Staff Report

To: Planning Commission

Meeting Date: December 14, 2023 (Prepared December 7, 2023)

Item: 1030 Young Street, "1030 Young Street Apartments" (DR 22-06)

3 TRASH ENCLOSURE SITE PLAN
SCALE: 1/4" = 1'-0"

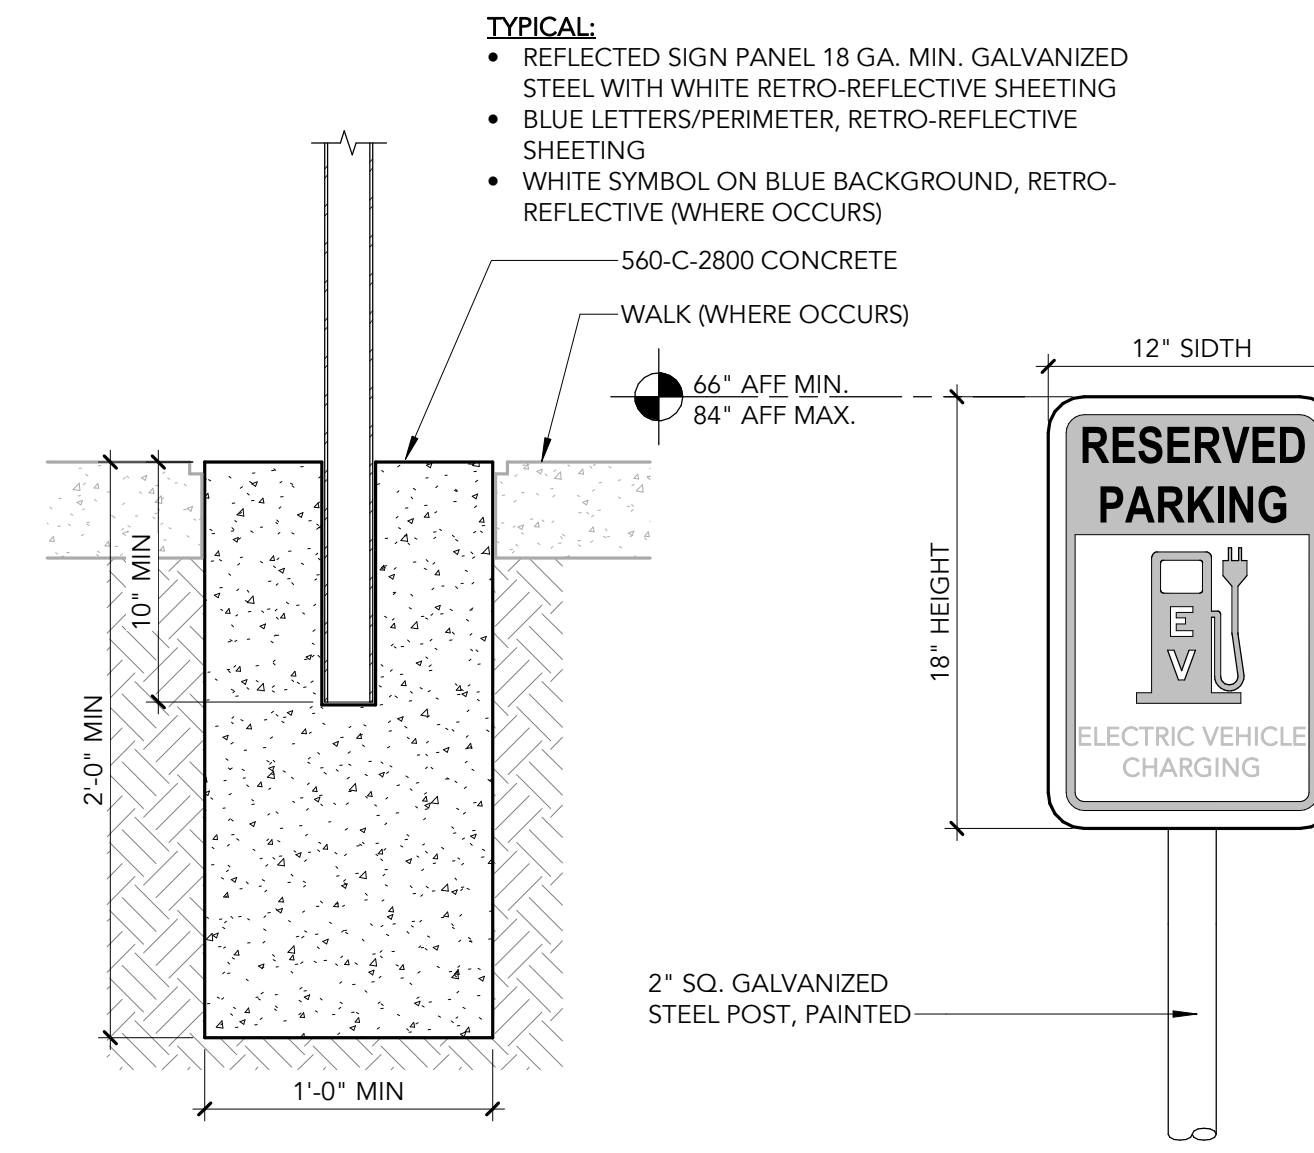
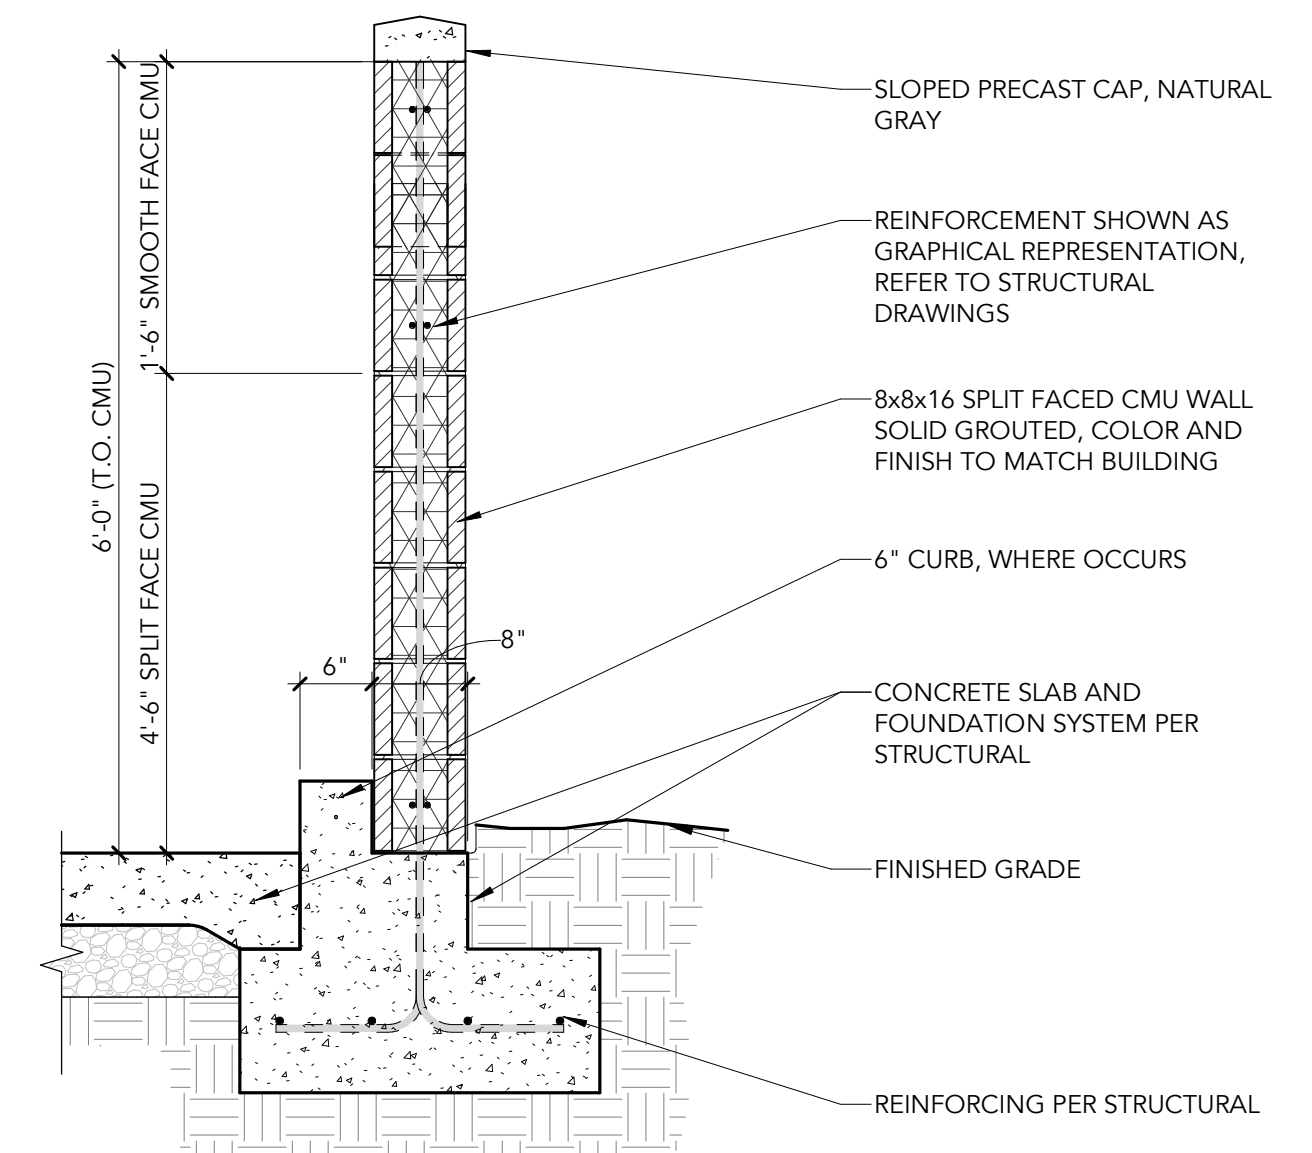
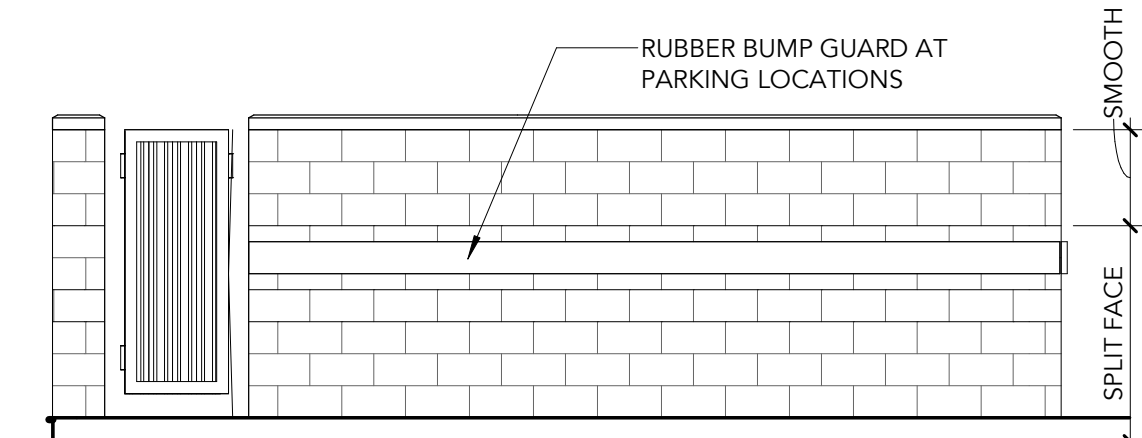
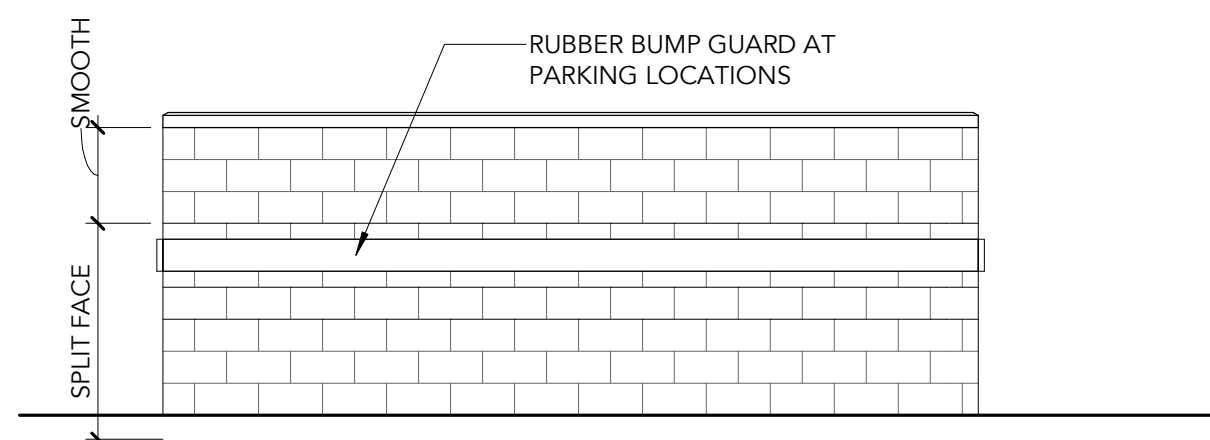
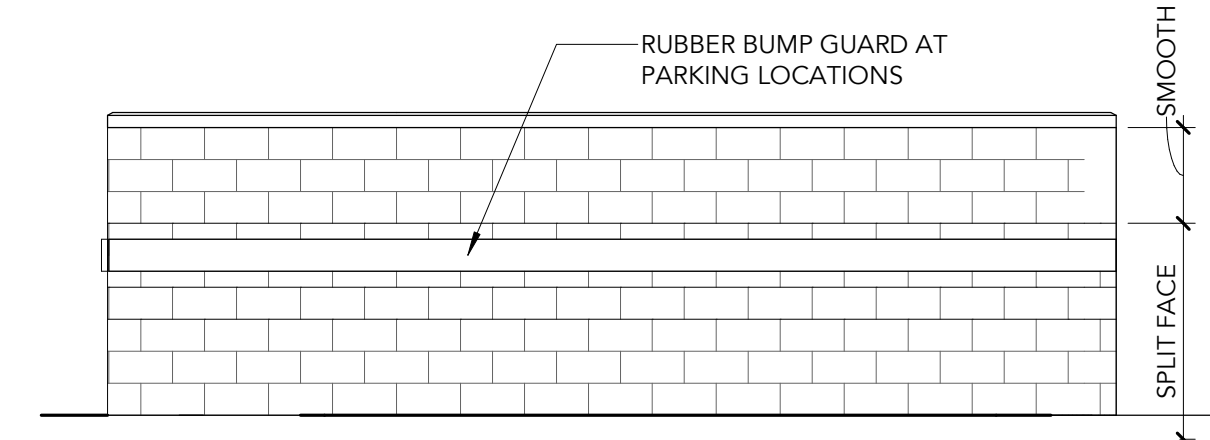
The Sheet LU1.1 recycling and trash enclosure typical plan and elevation views for the walls of the proposed three enclosures do not clearly conform to:

- a. Color placement: The developer shall revise elevation notes to indicate colors other than gray to conform with WDO 3.06.06B.6.
- b. Gate swing: The developer shall revise the enclosure plan view to indicate that the proposed gate for the required pedestrian opening, if it remains gated, swings inward to conform with WDO 3.06.06D.
- c. Vehicle protection: If an enclosure side is flush with a parking stall, there shall be a rubber bump guard (against vehicle door and side view mirror strikes) in height, mounting height, and extent as land use Sheet LU 1.1 elevations represent and call out.

Exhibit C4 Drive aisles south dead-end stubs

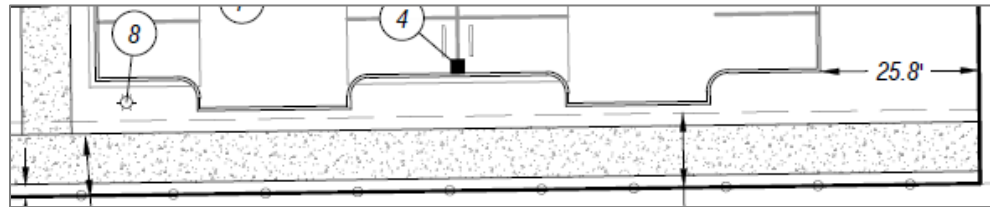
- b. Pavement: In any case, Path RR2 pavement min width shall be as follows:
 - (1) East: East of Walkway R1, 8 ft, which may abut curb width of drive aisles south dead-end stubs that Exhibit C4 shows below.
